ITEM 9.3	1 KING STREET, CONCORD WEST - PROPONENT PLANNING PROPOSAL
Reporting Manager	Acting Senior Strategic Planner Manager Strategic Planning
Attachments:	<ol style="list-style-type: none">1. Attachment A - Planning Proposal Report PP2023-0003 (<i>Provided in Attachment Booklet</i>)2. Attachment B - Visual Impact Assessment PP2023-0003 (<i>Provided in Attachment Booklet</i>)3. Attachment C - Social Impact6 & Needs Assessment PP2023-0003 (<i>Provided in Attachment Booklet</i>)4. Attachment D - Economic Impact Assessment PP2023-0003 (<i>Provided in Attachment Booklet</i>)5. Attachment E - Arch & Design Concept Plans PP2023-0003 (<i>Provided in Attachment Booklet</i>)6. Attachment F - Urban Design Report PP2023-0003 (<i>Provided in Attachment Booklet</i>)7. Attachment G - Design for Country Scoping Report PP2023-0003 (<i>Provided in Attachment Booklet</i>)8. Attachment H - Aboriginal Heritage Due Dill PP2023-0003 (<i>Provided in Attachment Booklet</i>)9. Attachment I - Transport Study Report PP2023-0003 (<i>Provided in Attachment Booklet</i>)10. Attachment J - Civil Design Report PP2023-0003 (<i>Provided in Attachment Booklet</i>)11. Attachment K - George Street Re-grading Civil Des

Figure 17: Preferred flood mitigation strategy – George Street (Source: Proponent)

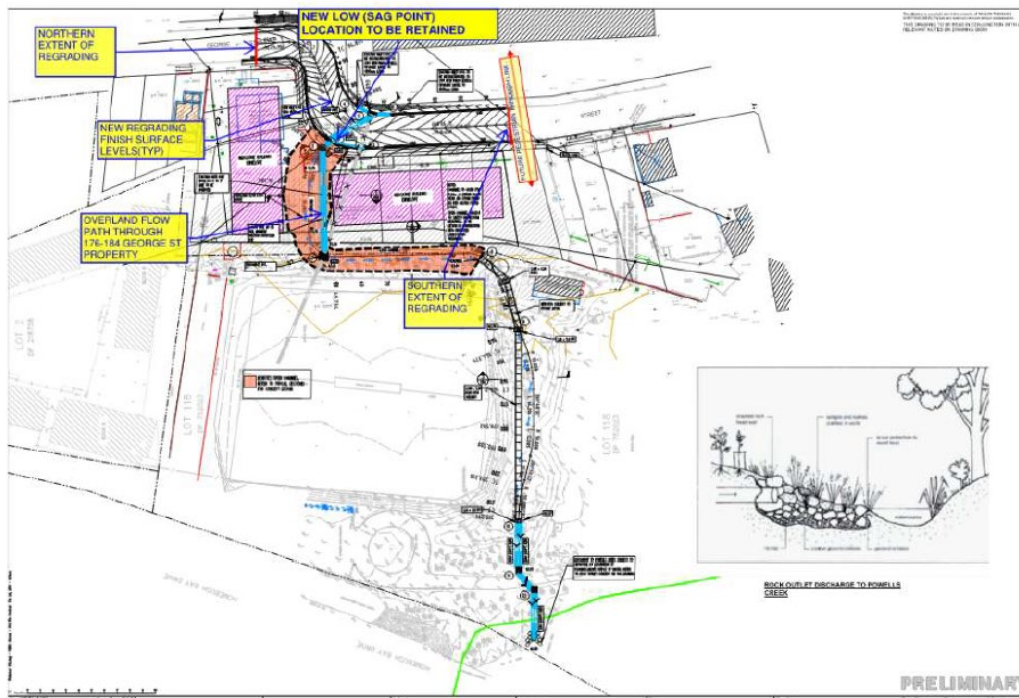
The 'George Street Sag', which is located at a low point, where George Street forms an 'S' bend opposite to 176-184 George Street, Concord West is within the Flood Planning Area. A mitigation strategy has been prepared for the George Street sag point, which reduces depths of flooding for the 1% AEP event. The Strategy will require the road to be raised by approximately 2.0 metres to enable stormwater to be discharge through a proposed easement over 176-184 George Street, Concord West into Powell's Creek.

Council proposes to progress the preparation of a detailed design for the mitigation works to the George Street Sag given the impending development at 176-184 George Street and a possible development on the subject site.

Prior to the Planning Proposal being submitted to the Department of Planning and Environment for a Gateway Determination, the flood assessment prepared on behalf of the applicant should be updated to consider the preferred mitigation strategy for George Street and demonstrate consistency with the 9.1 Direction for Flooding.

Figure 23: 3D visual comparison between the height of buildings shown in the illustrative masterplan (in blue) compared to the max HOB proposed in the Planning Proposal (shown in purple) (Source: Studio GL)

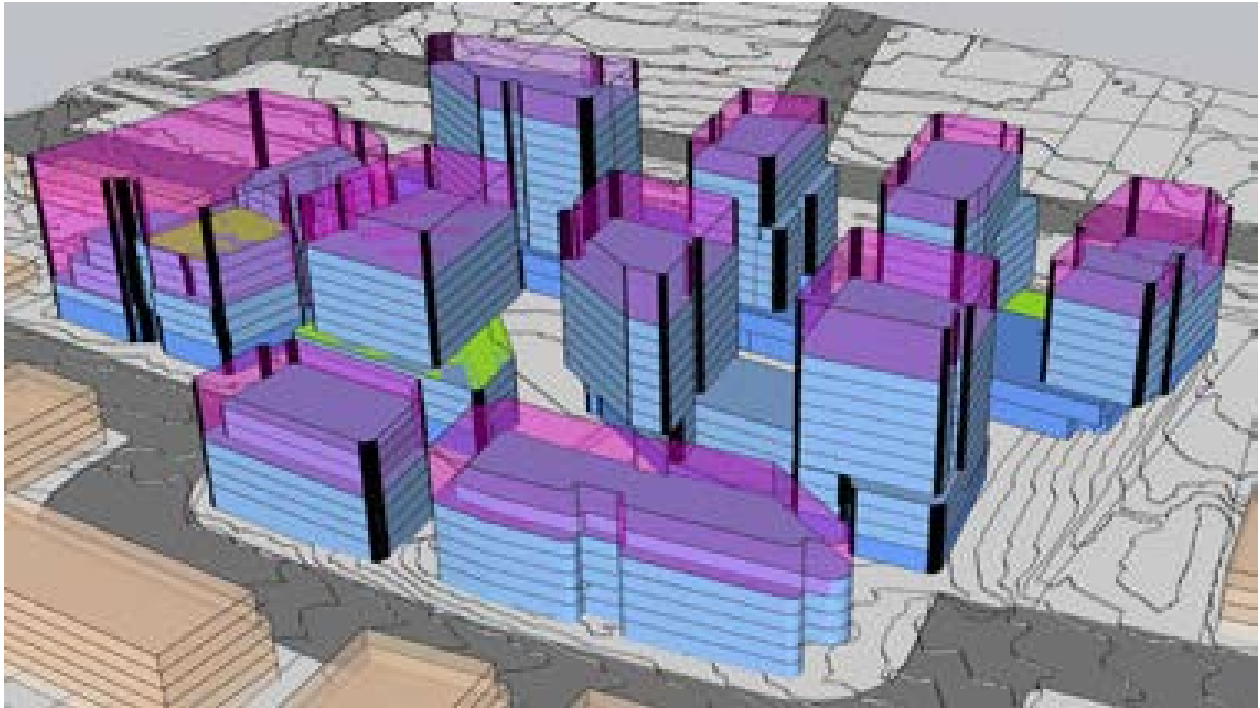
The Planning Proposal seeks to amend the maximum height of building standard to permit building heights that are significantly higher than shown in the supporting indicative master plan. This is problematic as the scale of development shown in the indicative masterplan is less than what could

occur should the LEP be amended as per the Planning Proposal. This could result in the extent of overshadowing being greater than shown in the shadow analysis, and the scale of future development being greater than shown in the visual impact assessment, which are based on the indicative masterplan not the LEP heights.

Figure 26: Eastern View: Planning Proposal building envelopes with proposed height in storeys
(Source: Studio GL)

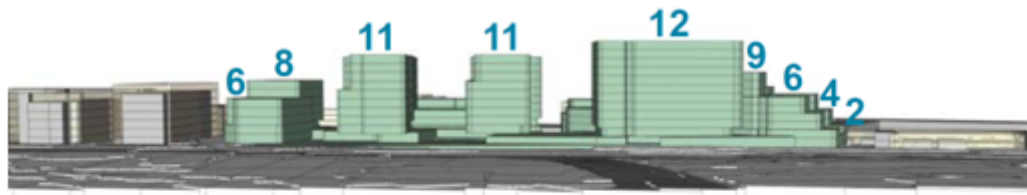
The Planning Proposal seeks to change the maximum building heights in the LEP from 8.5m to a range of maximum building heights ranging from 26m to 47m (see Figure 24 below).

Figure 27: Eastern View: Recommended building envelopes with height in storeys (Source: Studio GL)

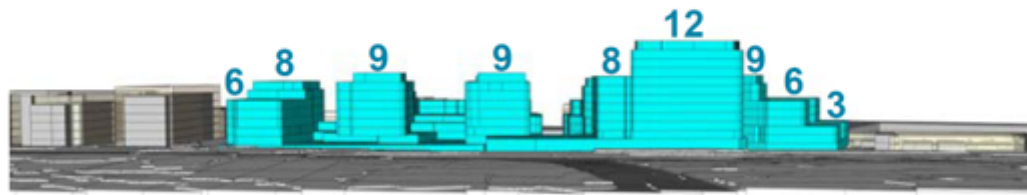
The recommended building heights are shown in Figure 25 below and at Attachment X.

Figure 29: Recommended Floor Space Ratio (Source: Council mapping)

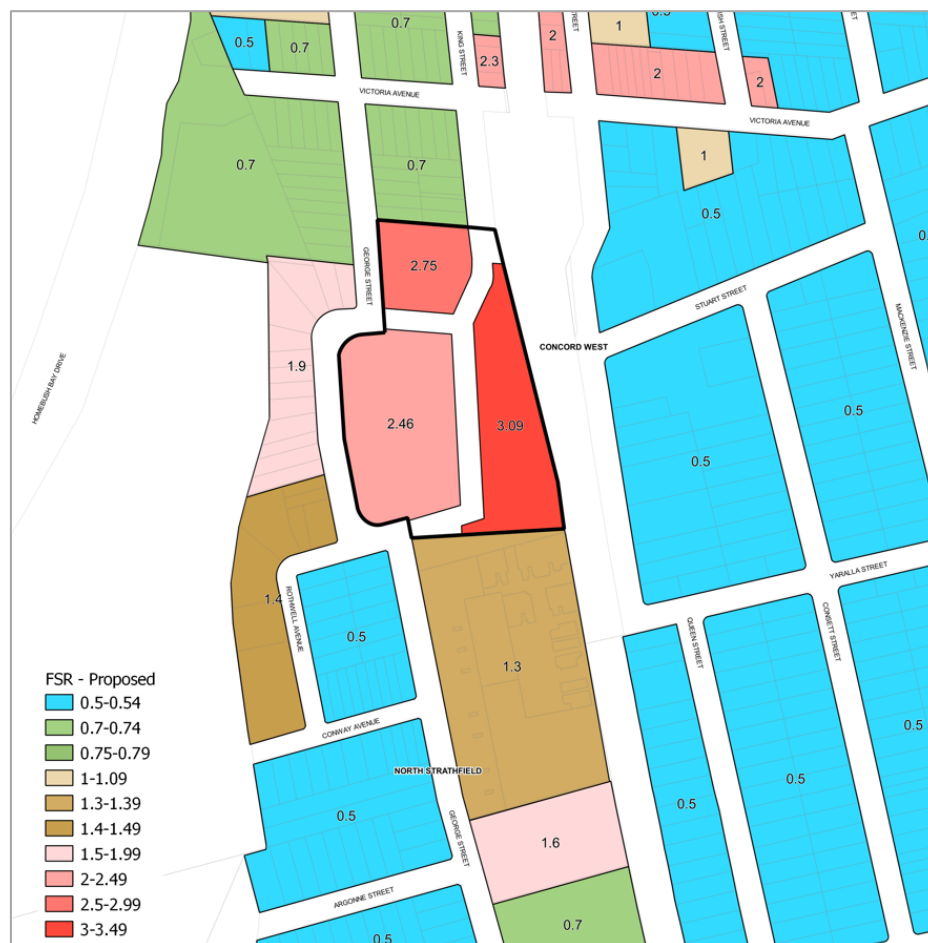
Council's independent urban design consultant has recommended a range of changes to the submitted illustrative masterplan that modifies building heights and alters the building envelopes in accordance with the *Apartment Design Guide*. The revised scheme achieves a Gross FSR of 2.23:1. For comparison, the Ashmore Precinct in Erskineville has a Gross FSR of between 1.0:1 and 1.25, Harold Park a Gross FSR of 1.15:1 and the recently rezoned Bushells site, a Gross FSR of 1.25:1.

- a local clause be included within the Planning Proposal that requires non-residential Gross Floor Area to comprise a minimum of 3,500m² and a maximum of 5,000m².
- deletion of proposed clause regarding the exclusion of enclosed balconies from Gross Floor Area.
- a maximum FSR of 2.23:1 be progressed for the Site with FSR standards being imposed on a block by block basis as illustrated in Figure 29 and at Attachment X.

Figure 30: George/Pomeroy Street layout – existing and proposed upgrade (Source: PWC)

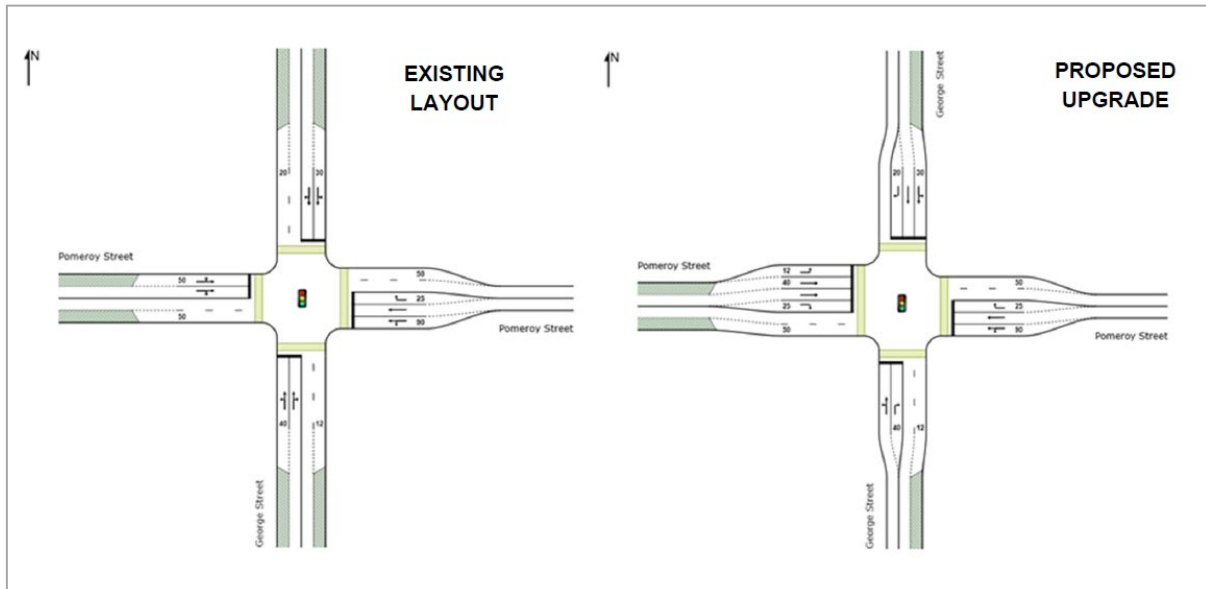
The Planning Proposal does propose to upgrade the intersection of George and Pomeroy Streets by providing additional capacity at the western and northern approaches, including:

- Additional dedicated right-turn and left turn bays at the western approach.
- At the northern approach, conversion of a departure lane to an approach lane for a dedicated right turn bay. The shared right and through is also converted to a continuous through lane.
- At the southern approach, conversion of movements to shared left turn and through movement at kerbside (continuous lane) and a right turning short bay at the median side.

Based on modelling outputs, the upgraded intersection is anticipated to operate with a Level of Service of 'C', representing an improvement over existing conditions.

Figure 31: Aerial photograph identifying 88 George Street, North Strathfield (Source: Council mapping)

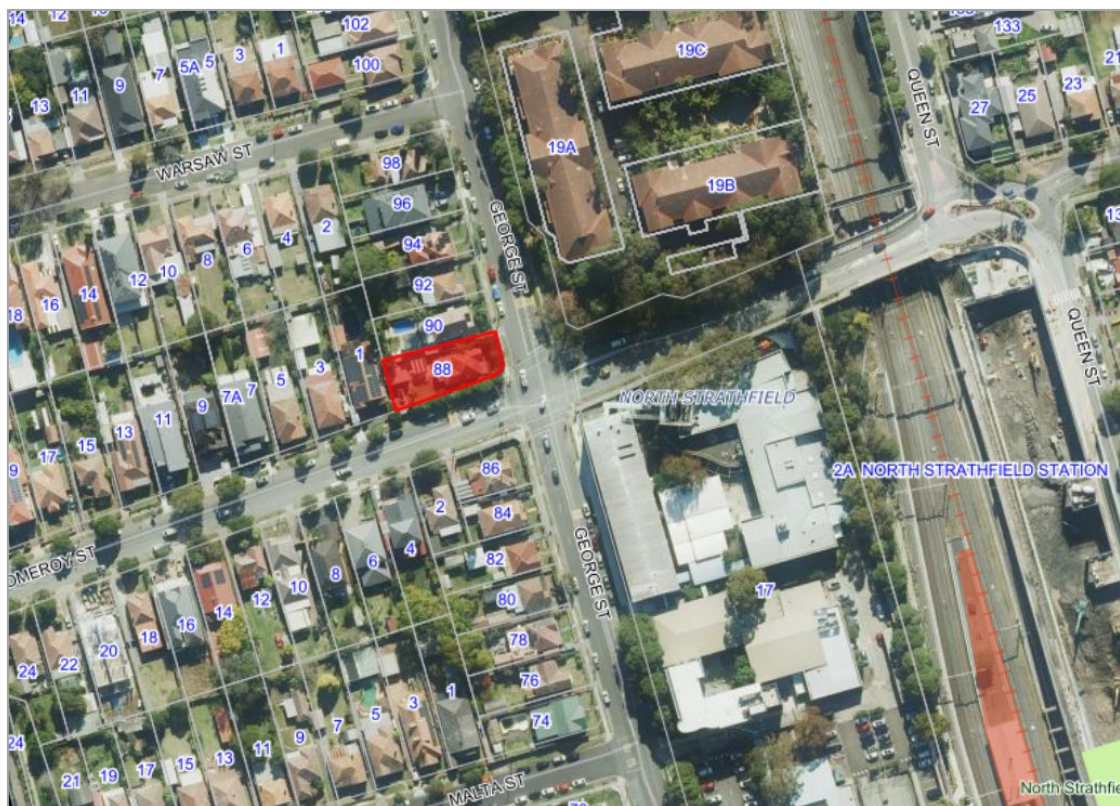
The upgrade of the intersection relies on the applicant having ownership or control of the land known as 88 George Street, North Strathfield (Lot 92 DP 651651) (see Figure 31 below). As this land is not within the ownership of the applicant, the upgrade is not able to be realised through the planning proposal or the associated 'letter of offer' to enter into a planning agreement.

Figure 32: Alternative George/Pomeroy Intersection Design (Source: Council concept)

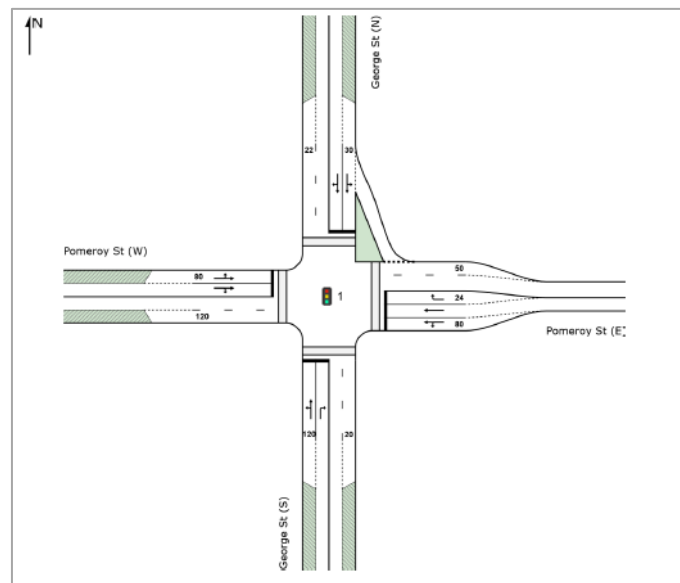
An alternative concept to upgrade the intersection has already been prepared by Council, predating the planning proposal. The main element of the upgrade is the provision of a left turn slip lane from George Street (north approach) to Pomeroy Street (east approach). Council is currently preparing a

The above design requires land (30.5m²) to be acquired from the property to the immediate east of the intersection (known as Strathaven at 19-21 George Street, North Strathfield or SP 50454). Any such acquisition would need to be identified on the Land Reservation Acquisition Map under the *Canada Bay Local Environmental Plan 2013*.

As the intersection upgrade is required to service the traffic generated by development arising from the planning proposal, it is recommended that the proposal does not proceed to a Gateway Determination until there is sufficient certainty that arrangements will be in place for the works to be funded. An update to the works schedule of the *Canada Bay Local Infrastructure Contribution Plan* is proposed to enable future development, the subject of the plan, to make a proportional contribution towards the intersection upgrade.
